RE: *Converse County Oil and Gas EIS Project*

Anadarko Petroleum Corporation (“Anadarko”) appreciates the opportunity to comment on the draft *Environmental Impact Statement* (“DEIS”) for the *Converse County Oil and Gas Project* (“Project”). Anadarko is one of several project proponent companies (known as the “Operator Group” or “OG”) that initiated this project planning effort in 2014. Anadarko hereby references and incorporates the comments provided by the OG in a separate letter submitted by Davis Graham & Stubbs LLP. Here, Anadarko seeks to both highlight certain elements of the DEIS that we find particularly important, as well as provide a subset of specific and unique comments.

Figure 1 – Nest buffers across the Project Area

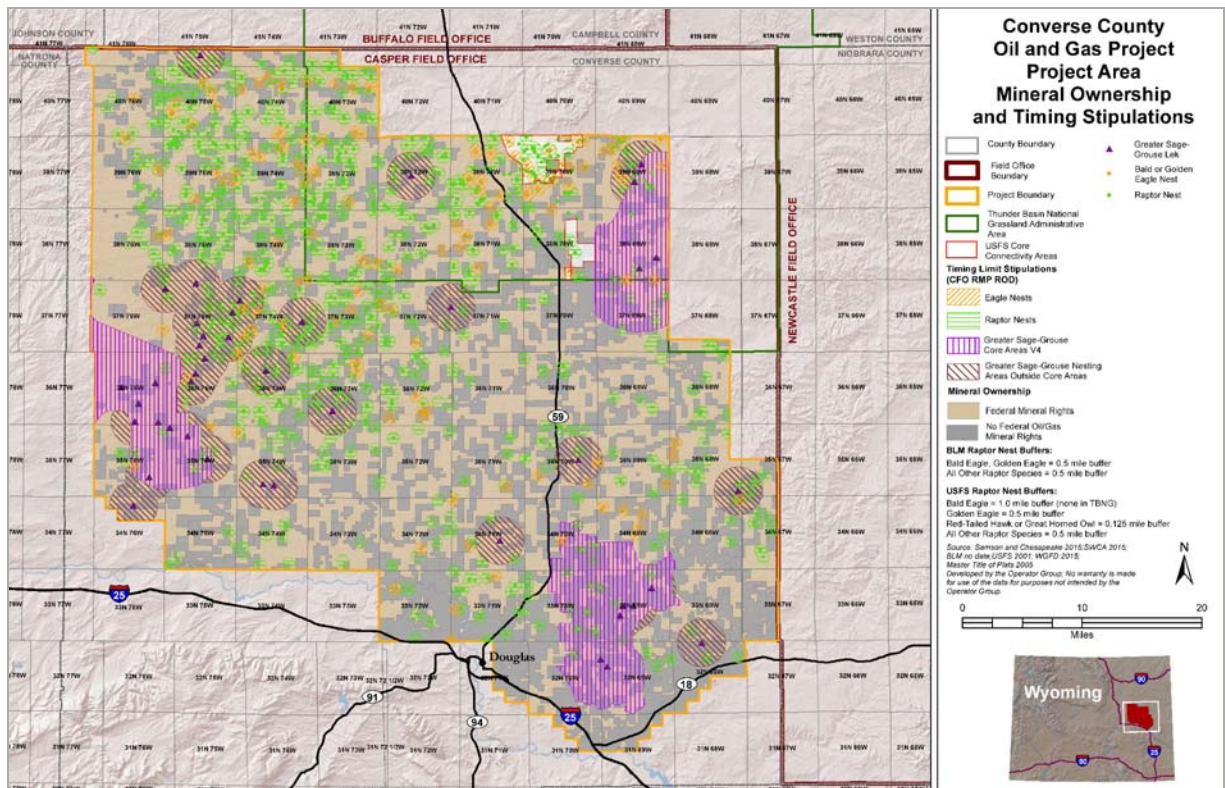
The first step in presenting the *conceptual example* was to develop a map (Figure 1) illustrating the currently identified raptor and sage-grouse nesting buffers within the Proposed Project Area. At least 1400 nest buffers exist in the Proposed Project Area. These nest buffers would include both active and inactive nests (i.e., some nests would not be used by birds in a given year). Nest buffers can have radii from a quarter mile to two-miles, encompassing from 0.2 to 12.5 square miles. One half mile buffers, common to many raptors, encompass about 0.8 square miles, or about one square mile of land for each nest buffer.

To demonstrate the number of well pads potentially located within these nesting buffers across the Proposed Project Area, the OG applied the *conceptual example* of one pad per two sections (i.e., one pad per each 1280-acre drilling and spacing unit) to the overall Proposed Project Area.

Figure 2 – Nest buffers and drilling pad location in one township – illustrative only

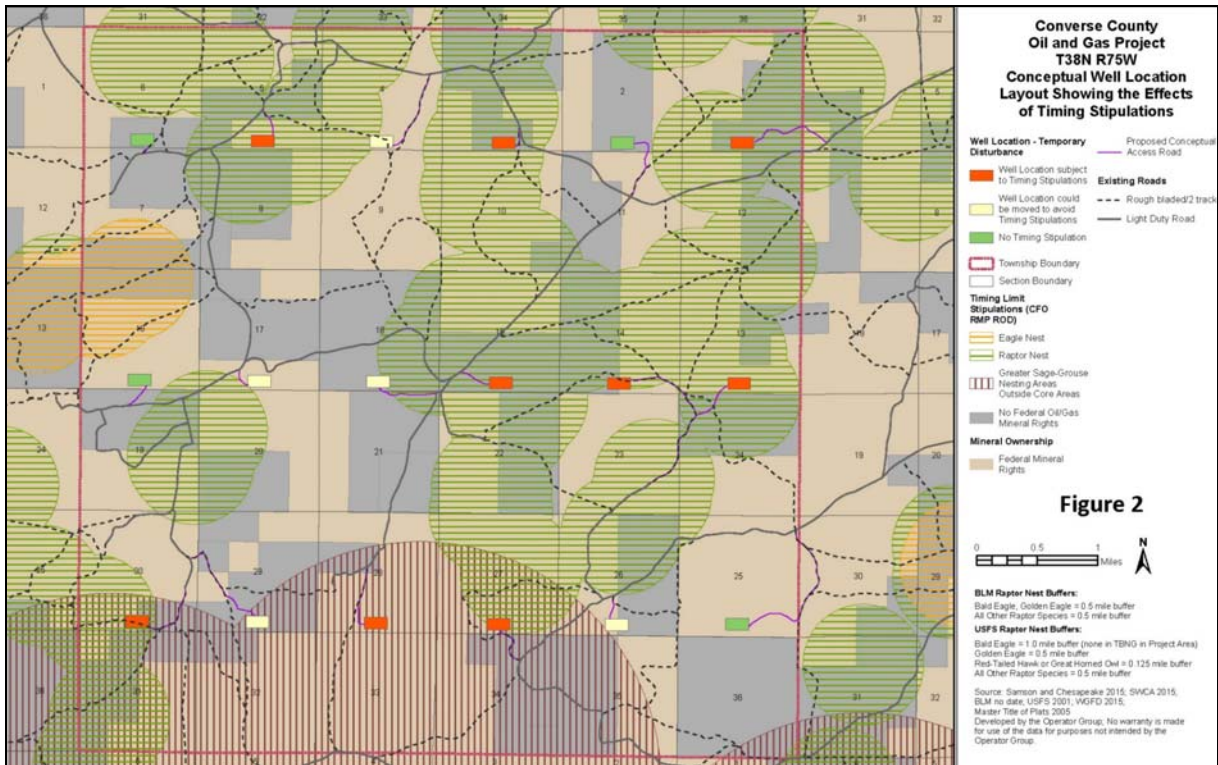
Figure 2 (T38N R75W) represents this *conceptual example* for a single township. The well pads are shown to scale as 12 acres in size, consistent with the estimated initial disturbance for well pad construction within the Proposed Action. In this particular township, four well pads (green) are not within nest buffers, while five well pads (yellow) would slightly overlap nest buffers, but would likely be re-located to avoid the nest buffer. Nine well pads (shown as red) could not be moved outside of the nest buffer in a manner that would still allow recovery of the mineral resource and would therefore be provided TLS relief as envisioned by the Proposed Action.

Even if operators are able to re-locate well pads to avoid nest buffers, interferences with nest buffers can occur due to roads and associated infrastructure. This *conceptual example* illustrates that road and well pad planning efforts to avoid activity or intrusion in all nest buffers is impossible. The Figure 2 Township has over 55 percent of the overall area with overlapping nest buffers and is not atypical for the Proposed Project Area overall. In fact, the results of this *conceptual example* suggests about 45 percent of all well pads in the Proposed Project Area would fall within nest buffers even after careful planning. Importantly, this *conceptual example* does not account for the other constraints on well pad and road locations such as avoidance of other resources such as wetlands, cultural artifacts, topographic constraints such as steep slopes, or private property-owner preferences – all of which make avoiding all nest buffers in the Proposed Project Area impossible.

The *conceptual example* indicates as many as 28 percent of all Proposed Action well pads within the Proposed Project Area would be within nest buffers that are non-core leks and non-eagle, raptor nest buffers in which operators would maintain continuous drilling and completion activities during the TLS period under the Proposed Action. About 17% of all Proposed Action well pads would fall within eagle or core area buffers, but the Proposed Action does not include year-round drilling within these nesting areas, as these are deemed by existing law and policy as higher priority wildlife habitats in comparison to non-core lek and non-eagle nest buffers.

Figure 3 – Eight-well Pad Scenario – Overall Construction-Drilling-Completions Schedule

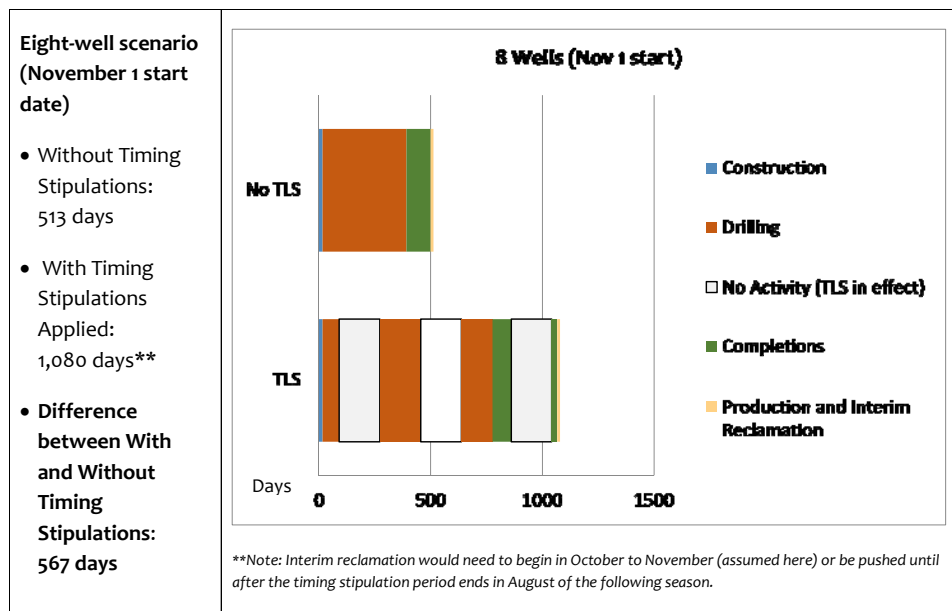
- Year-Round Drilling Rig Move Analysis:** The second factor (the first is the high density of nests across the project area) driving the need for year-round drilling is the length of time needed to construct, drill and complete multiple horizontal wells on a single pad. The OG provided information to BLM during the development of the DEIS as to the time it takes to complete multi-well drilling and completion operations on a given pad. The OG estimated that if four or more wells emanate from an individual pad, the time it takes to construct, drill, and complete the wells exceeds the time between annual nest buffer TLS periods. For an eight-well pad, three separate drill rig mobilizations might be needed to complete the pad while adhering to TLS as indicated on Figure 3 below:

In summary, as many as 45 percent of pads constructed in the project area are within nest buffers and cannot be avoided by pad placement planning. If these pads have more than four wells on them, operators will either:

BLM needs to bolster in the FEIS the description of the timing it takes to drill and complete multi-well pads and highlight that the Proposed Action includes year-round drilling to reduce the environmental and socio-economic impacts associated with increased rig mobilizations.
